ADA Curb Ramp New Construction Inspection Form (Parallel)

24952.54			
North-South Road Name	Project No.	Sheet No.	Intersection No.	East-West Road Name

PARALLEL RAMP (PL)

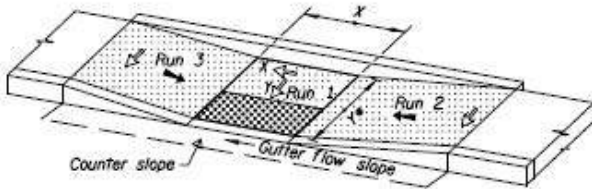
Crack ramp run 3
